<b>Docket Number:</b>	24-OPT-05
<b>Project Title:</b>	Corby Battery Energy Storage System Project
<b>TN #:</b>	268433
<b>Document Title:</b>	Project Description Update #2, Part 2
<b>Description:</b>	Project Description Update #2, Part 2
<b>Filer:</b>	Doug Urry
<b>Organization:</b>	Tetra Tech
<b>Submitter Role:</b>	Applicant Consultant
<b>Submission Date:</b>	1/30/2026 5:03:16 PM
<b>Docketed Date:</b>	2/2/2026

# Project Description Update

## #2, Part 2

### Corby Battery Energy Storage System Project

## Figure 3.1-6 KOP 6

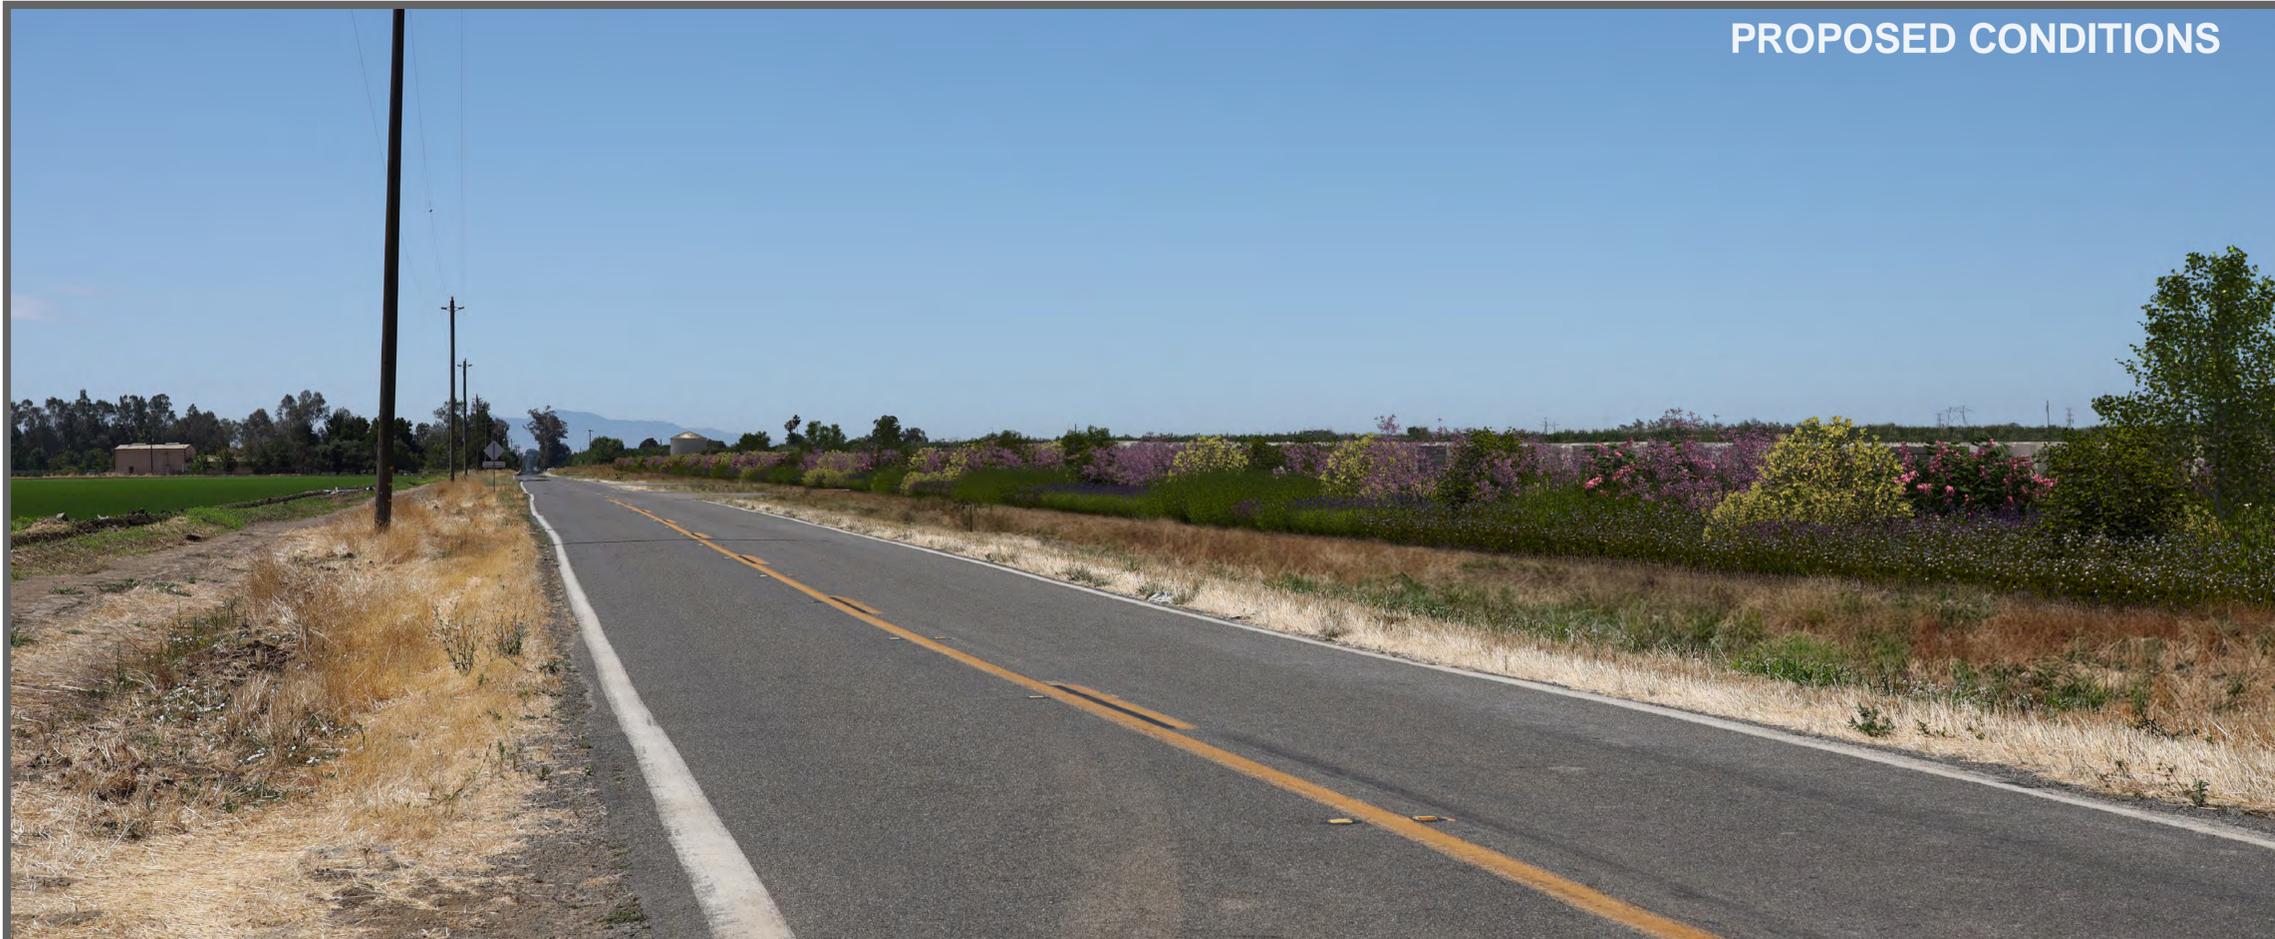
A complete set of revised simulations has been provided for review and provided as Figures 3.1-1 through 3.1-12. The addition of the CLRs and the adjustments to the substation layout will be visible from key observation point (KOP) 2a, KOP 3, KOP 7a, and KOP 7b, as shown in Figures 3.1-3, 3.1-4, 3.1-9, and 3.1-11 as well as the updated KOP 2a, KOP 3, KOP 7a, and KOP 7b Bureau of Land Management (BLM) Visual Contrast Rating Worksheets (Form 8400-4) provided as Appendix 3.1-A. The BESS layout will be visible from KOP 2a, KOP 2b, and KOP 3, as shown in Figures 3.1-2, 3.1-3, and 3.1-7, as well as the updated KOP 2a, KOP 2b, and KOP 3 BLM Visual Contrast Rating Worksheets (Form 8400-4) in Appendix 3.1-A. The addition of the CLRs will blend in with the remainder of the substation equipment; the updated simulations and forms reflect the minor changes that are visible from these KOPs. The addition of the CLRs and adjustments to the substation layout will appear substantially similar to the layout previously analyzed in the Application and the Project Description Update #1 and will not result in a change to visual contrast. The BESS units will be slightly larger in length and width as shown in Table 3.1-1<sup>1</sup>. The small increase in BESS unit size creates slightly more visual prominence than the previously proposed model. The water tank will be located closer to Byrnes Road and slightly more visibly prominent. However, the BESS and the water tank will both continue to be gray, similar to other Project elements (Project substation, fencing, and sound barrier) and to the existing structures (roadway, agricultural structure, and transmission towers and lines). The contrast determined for the BESS and the water tank will be the same as that previously discussed in Project Description Update #1. They will contrast with the undeveloped agricultural land but will be consistent with the horizontal and vertical lines and colors of other human-made structures throughout the landscape. While they will introduce a contrast, they will blend in with the other Project elements and therefore not increase the contrast created by the Project. Views for local motorists would be of short duration due to partial or full blockage of views by vegetation and structures prior to approaching the Project site, which will limit view accessibility of the Project including these components by continuing to soften the contrast between the agricultural land and the Project. As the landscaping matures in height and fills out, the landscaping will largely obscure the Project, reducing the contrast with agricultural land.

(Replaces Figure 4.1-11b)

Figure A-2  
Updated Project Layout

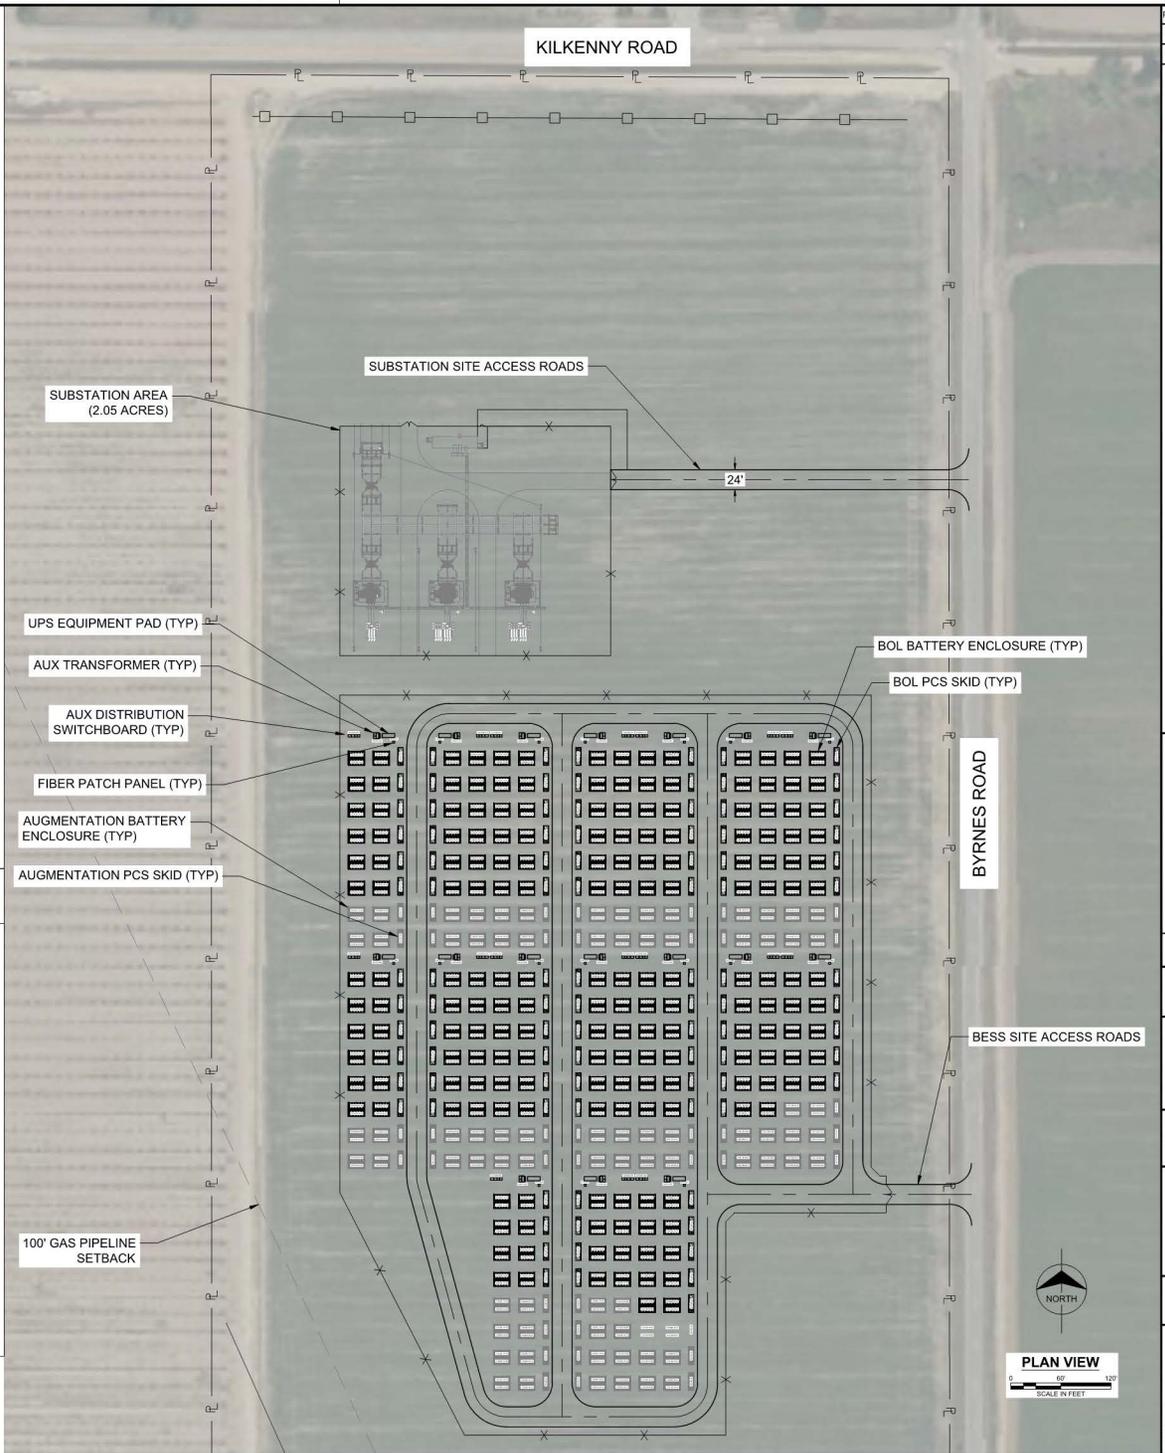
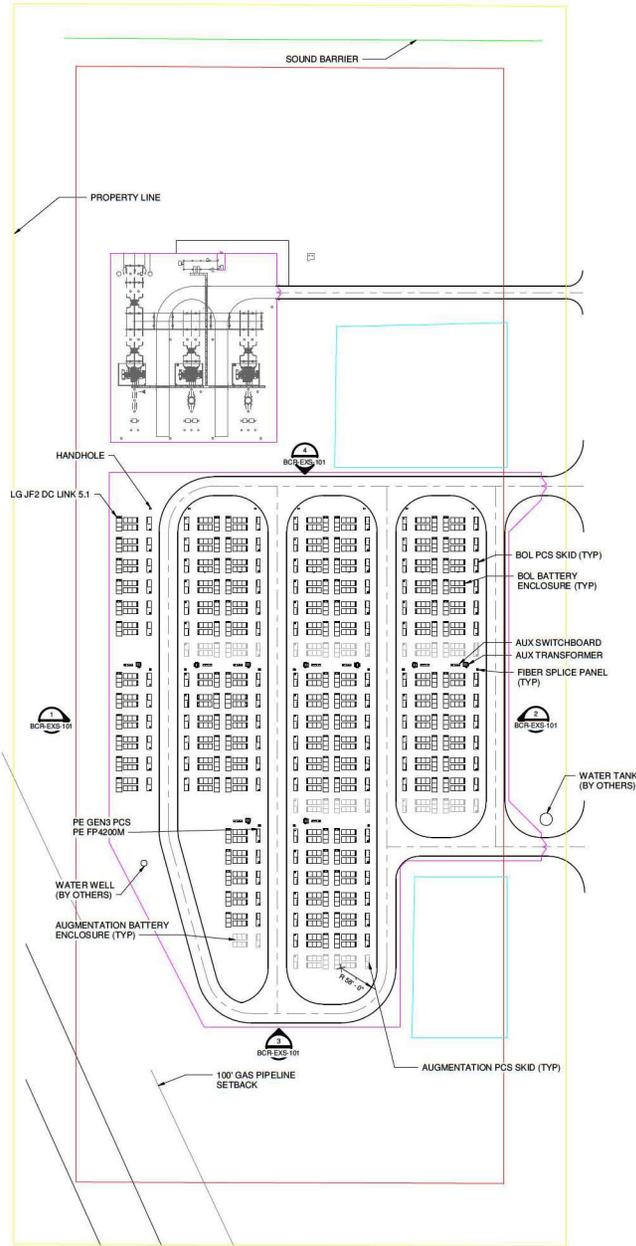
The original design of the Project included 544 CATL Ener C+ Battery Containers and 136 Power Electronics GEN3 inverters. Project sound sources were modeled according to the locations provided in the general arrangement drawing provided as Figure A-1 of Attachment A.

As development has progressed in the Project, the original equipment and manufacturers have changed. The new Project sound sources were modeled according to the locations provided in the revised general arrangement drawing provided as Figure A-2 of Attachment A.
